ACCELERATED DISTRIBUTION DEMONSTRATION SYSTEM

SUBJECT: Forwards comments on proof & review version of Tech Specs
 issued to util on 880609, in form of marked-up pages.

Re: Turkey Point Units 3 and 4
Docket Nos. 50-250 and 50-251
Revised Technical Specifications
Proof and Review Comments

Figure 3.1-1
Required Shutdown Margin vs Reactor Coolant
Boron Concentration

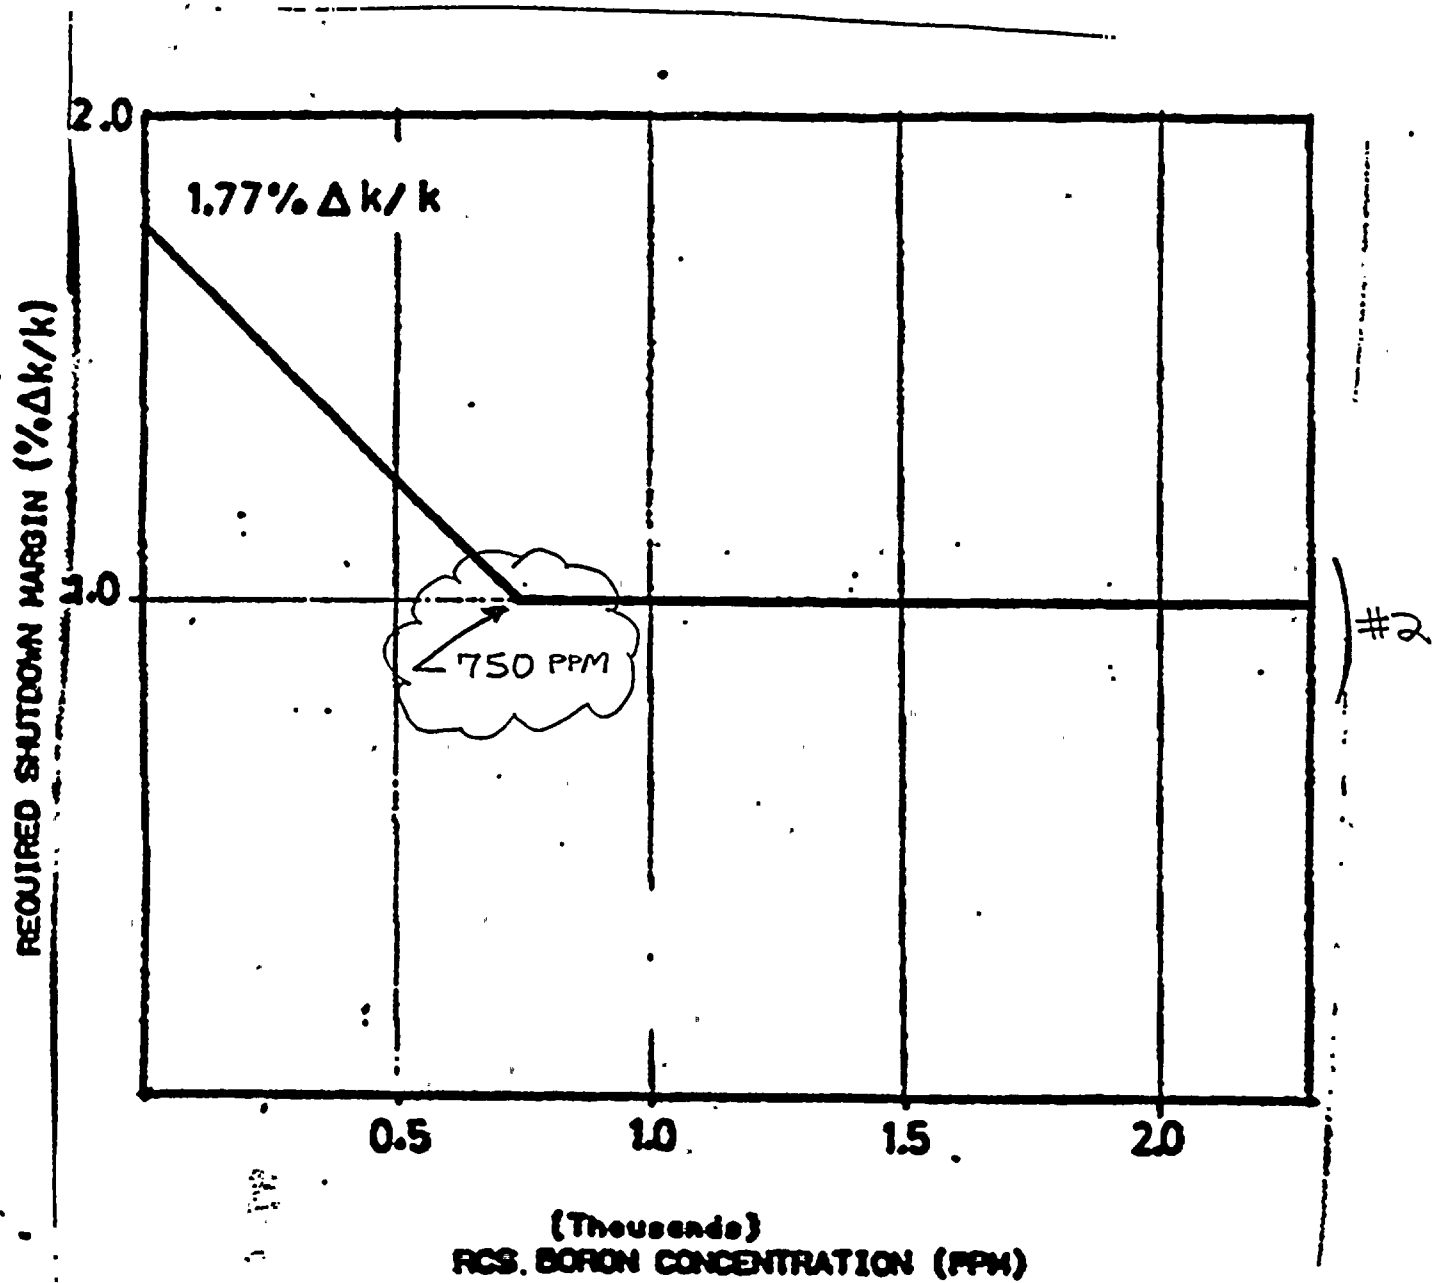
1. BASES - Revised to reflect actual condition addressed by the LCO. "Postulated steam line break" appears inappropriate with RCS temperature below 200F.
2. Figure 3.1-1: Breakpoints should be shown for operator clarity.
3. During the first 60 EFPD of a cycle, it is possible that an adjustment to the letdown curve may not have to be made if there is good agreement between measured data and design figures.

FIGURE 3.2-1

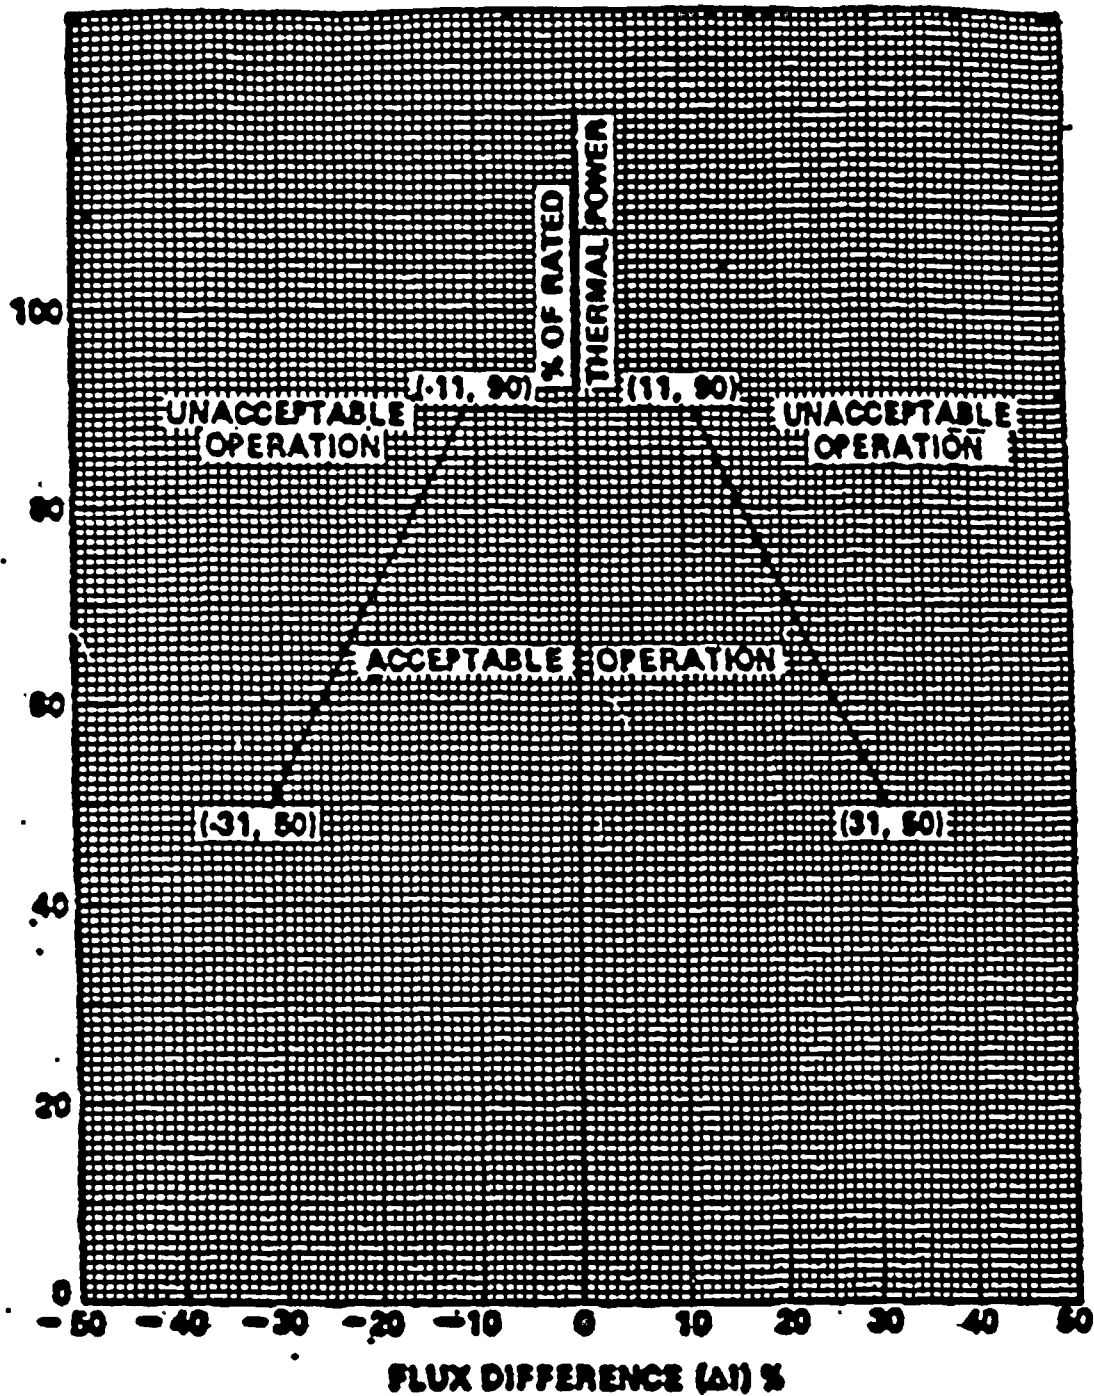
REPLACE
WITH FPL
WORDING

FIGURE 3.4-2
TURKEY POINT UNIT 3
REACTOR COOLANT SYSTEM HEATUP LIMITATIONS - APPLICABLE UP TO 10 EFY

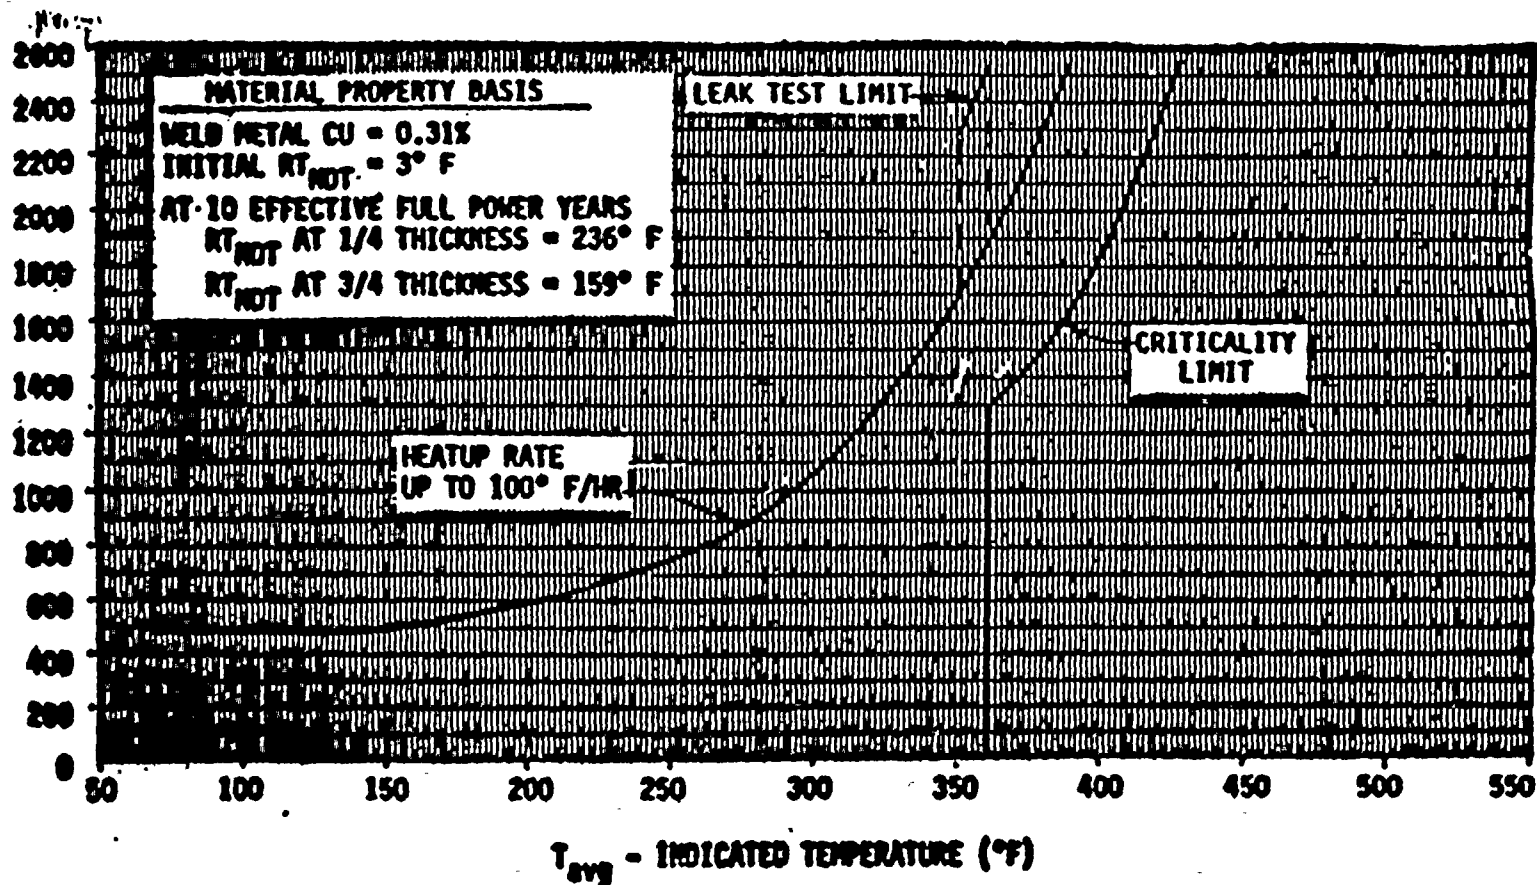
ADD ATTACHED
INSERT

FIGURE 5.1-1 SITE AREA MAP

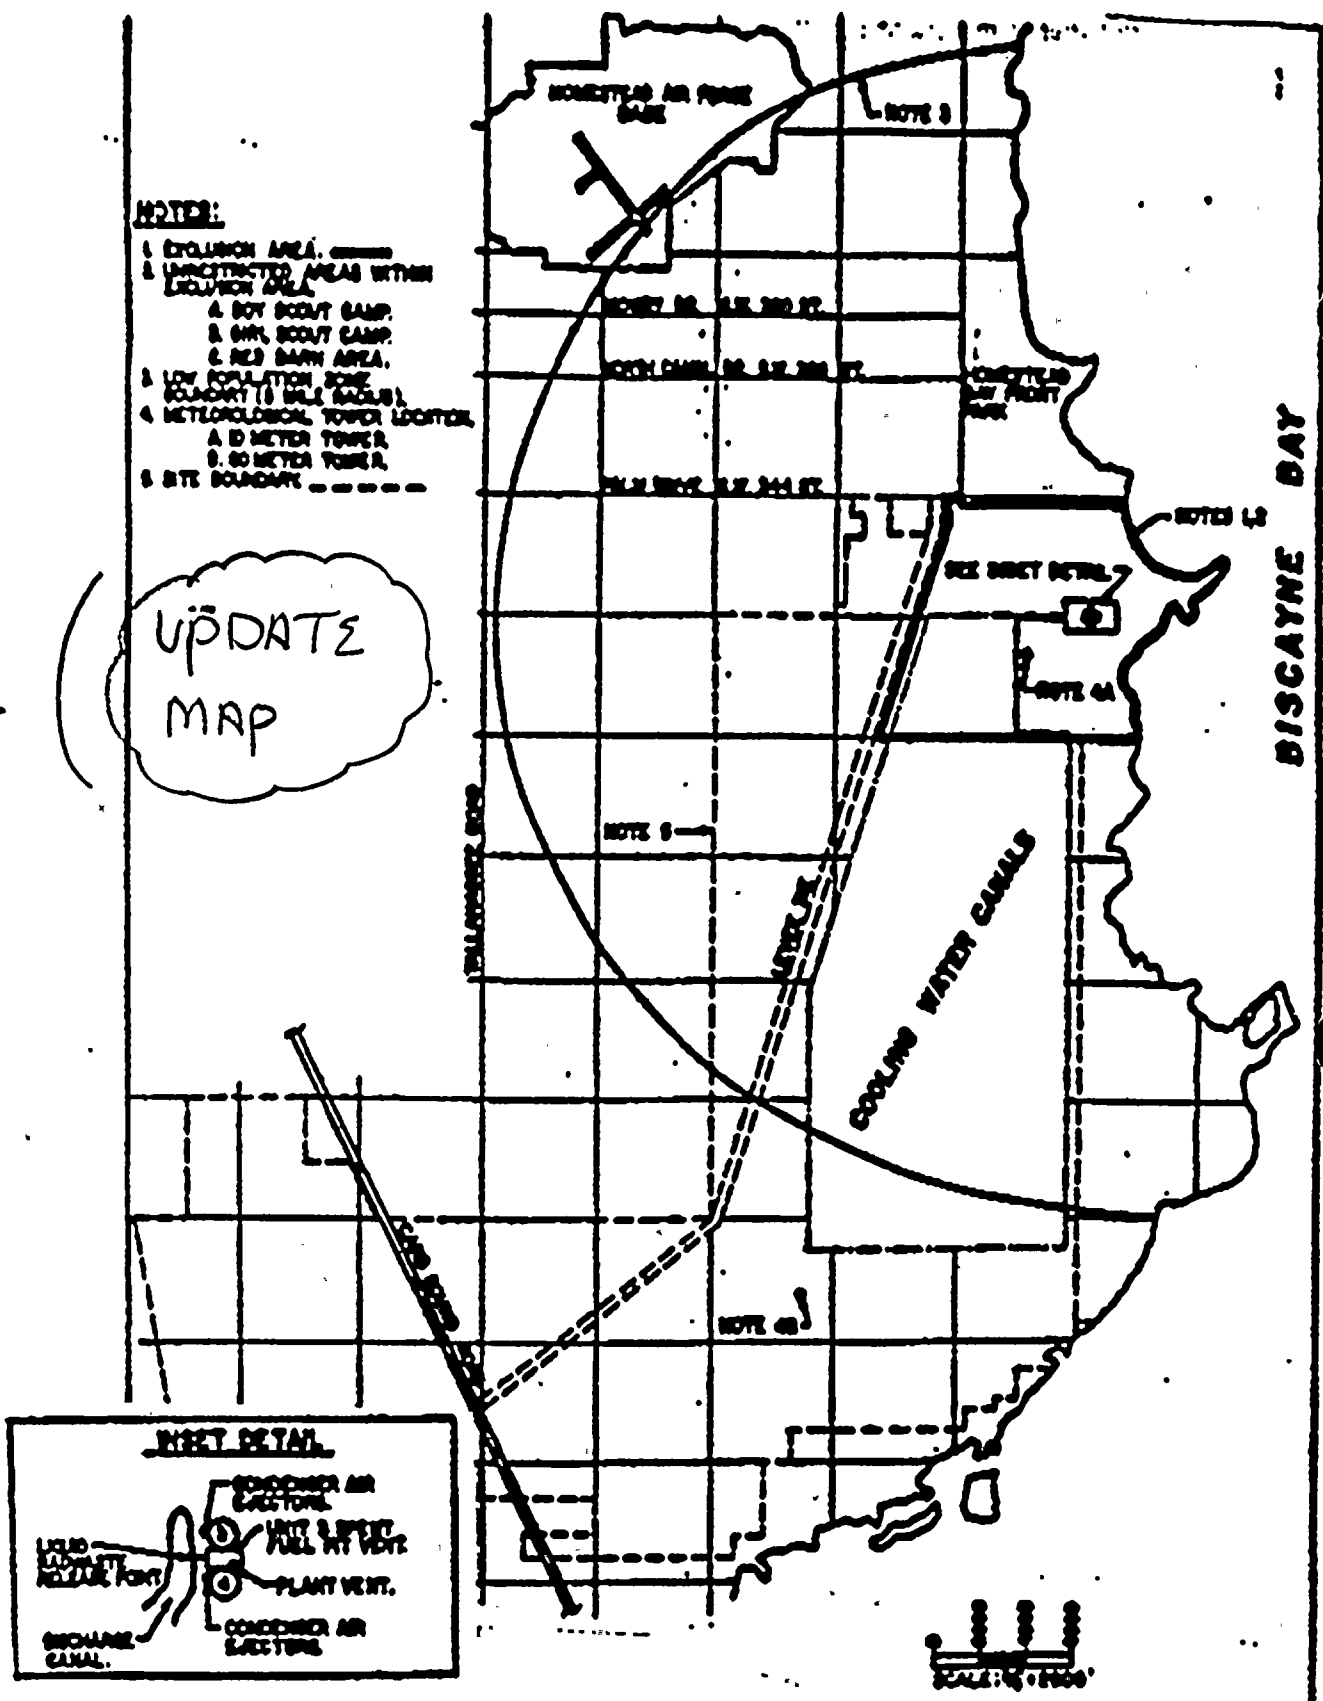
UPDATE
MAP
